ADDENDUM #2

- A. Project Number: 2024-626
- B. Project Title: YTC 872 HVAC & Water Heater Replacement
- C. Project Location: Yakima Training Center, 1221 Firing Center Road, Yakima County, WA 98901
- D. Agency: Washington Military Department

Fume Extractor Arm Schedule

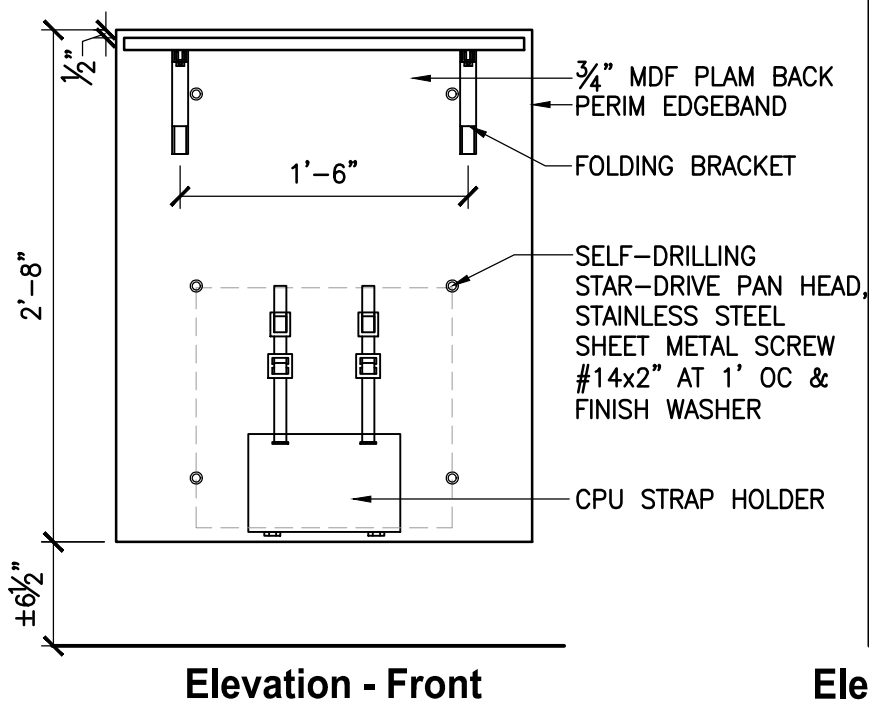
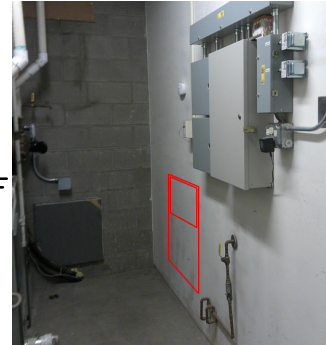
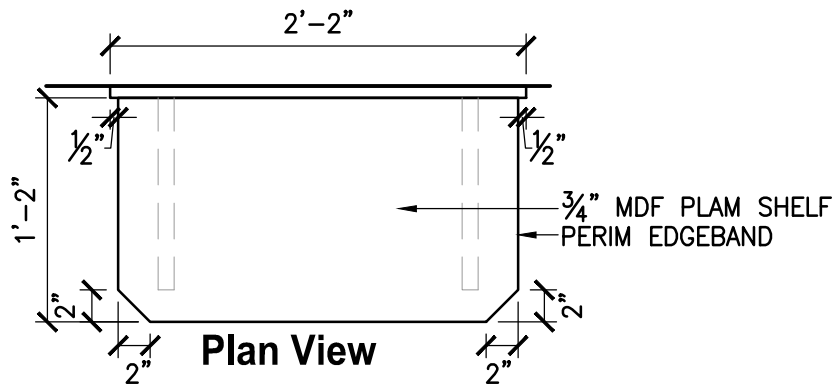
Manufacturer:

ADD, “approved equal: AQC, Maxair”

Wall-Mounted Control Desk Detail

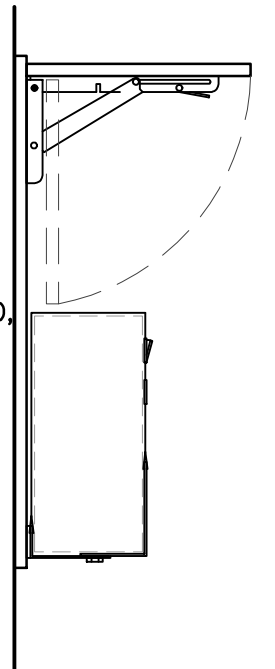
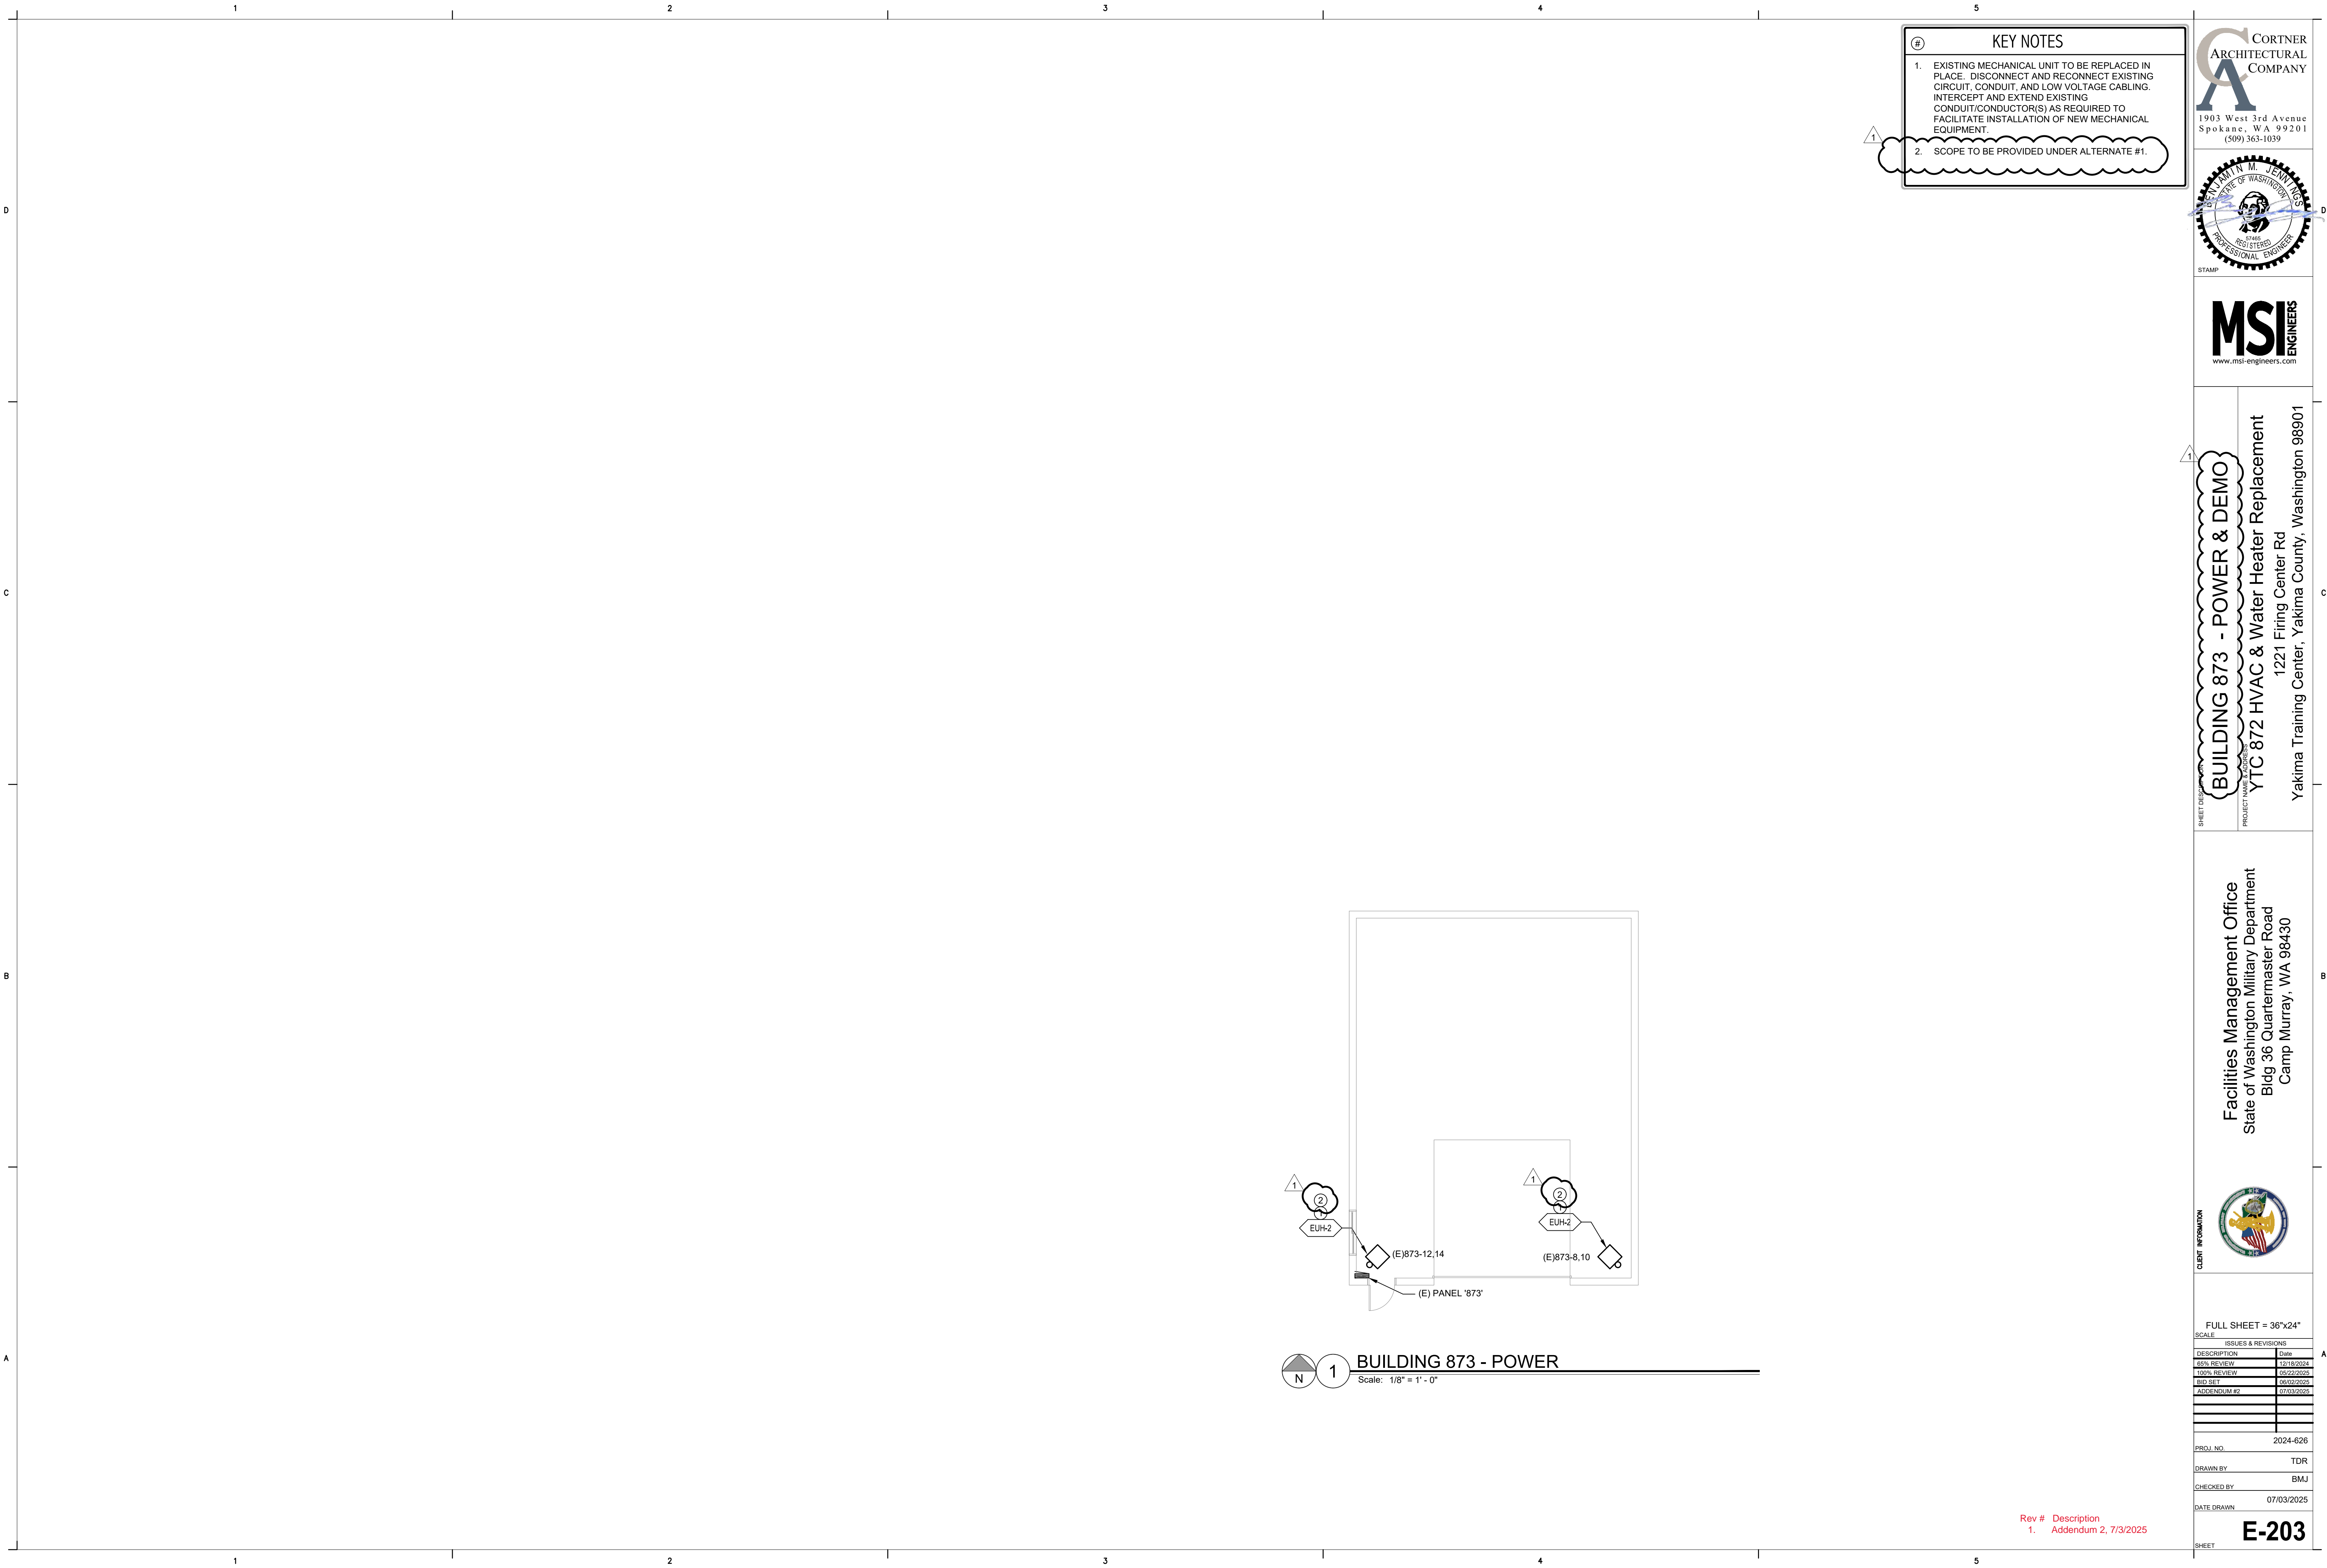
- A. Sheet G-001, Cover Sheet
Sheet Index
DELETE
E-203 Roof Plan – Power & Demo
REPLACE WITH
E-203 Building 873 – Power & Demo
- B. Sheet A-201, Floor & Reflected Ceiling Plan
ADD Detail 1 (see Supplemental Instruction SI.A-01, attached)

Floor Plan, Mechanical Room 102
ADD note & leader arrow pointing to north end of east wall:
“PROVIDE WALL MOUNTED CONTROL DESK, SEE DETAIL 1/SHEET A-201”
- C. Sheet M-002, Mechanical Schedules
Exhaust Fan Schedule, EF-4, Motor
DELETE
1/3 HP & 115/1 V/Ph
REPLACE WITH
3/4 HP & 108/3 V/Ph
